# UNITED STATES PATENT AND TRADEMARK OFFICE

APPLICATION NO.	FILING DATE	FIRST NAMED INVENTOR	ATTORNEY DOCKET NO.	CONFIRMATION NO.
10/632,545	08/01/2003	Michael F. Brletich	12539	2681

<b>Office Action Summary</b>	<b>Application No.</b> 10/632,545	<b>Applicant(s)</b> BRLETICH ET AL.	
	<b>Examiner</b> Ernesto Garcia	<b>Art Unit</b> 3679

## **DETAILED ACTION**

FIG. 35

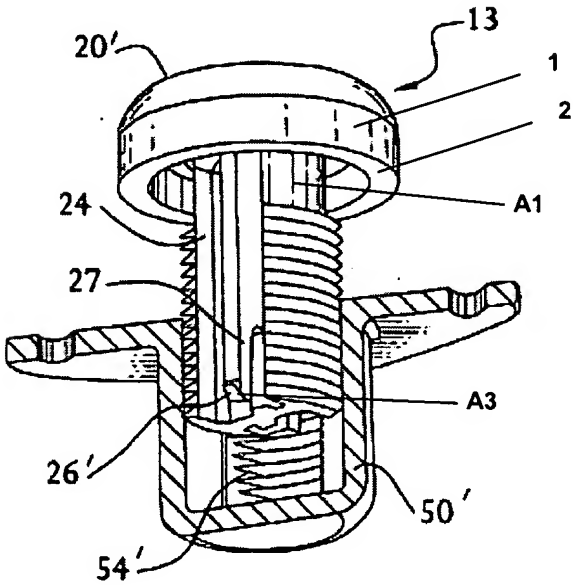
Regarding claim 1, Antonucci et al. disclose, in Fig. 35, a device comprising a fastener plug **13** including a plug portion **20'** and a fastener portion **24**. The plug portion **20'** defines an end cap **20'** and at least one disc **28** spaced apart from the end cap **20'**. The fastener portion **24** defines a flexible extension member **27** extending outwardly from the end cap **20'** and across the at least one disc **28**. The extension member **27** includes a projecting member **26'**. Given the structure of Antonucci et al. above, the disc is sized and shaped to mate with and seal an open end of a bar. The flexible extension member is able to flex as the member is installed in the open end of the bar and snap back to an original position when the projection member engages an aperture in a sidewall of the bar. Further, the disc defines a diameter slightly larger than a diameter of the open end of the bar, and the projection member can be adapted for operatively engaging the aperture in the sidewall of the bar.

Regarding claim 2, the end cap **20'** defines a peripheral edge **B1** (see marked-up attachment) and a flat surface edge **B2** along the peripheral edge **B1**. Note, the claims are written with a broad breadth that Antonucci et al. reads on this claim. Applicants should consider rephrasing that the peripheral edge has a truncated edge or truncated surface.

Regarding claim 3, a rib **A1** connects the disc **28** to the end cap **20'** (see marked-up attachment provided in the Office action mailed on 7/14/2005).

Regarding claim 4, the disc **28** is a plurality of discs **28** spaced apart from the end cap **20'**.

Regarding claim 5, the extension member **27** extends upwardly from the end cap **20'**.

Regarding claim 6, the extension member **27** extends across the discs **28**.

Regarding claim 7, the discs **28** define a flat surface edge **A2**.

Regarding claim 8, the projection member **26'** defines an inclined surface **A3**.

Regarding claim 15, Antonucci et al. disclose, in Figure 35, a device comprising a fastener plug **13**. The fastener plug **13** includes an end cap **20'** and discs **28** spaced apart and connected to the end cap **20'** by at least one rib **C1** (see marked-up attachment). The end cap **20'** defines a peripheral edge **B1** and a flat surface edge **B2** along the peripheral edge **B1**. The fastener plug **13** includes an extension member **27** extending outwardly from the end cap **20'** and across the discs **28**. The extension member has a fixed end connected to the end cap **20'** and a free end opposite the fixed end. The free end includes an aperture engaging-member **26'**.
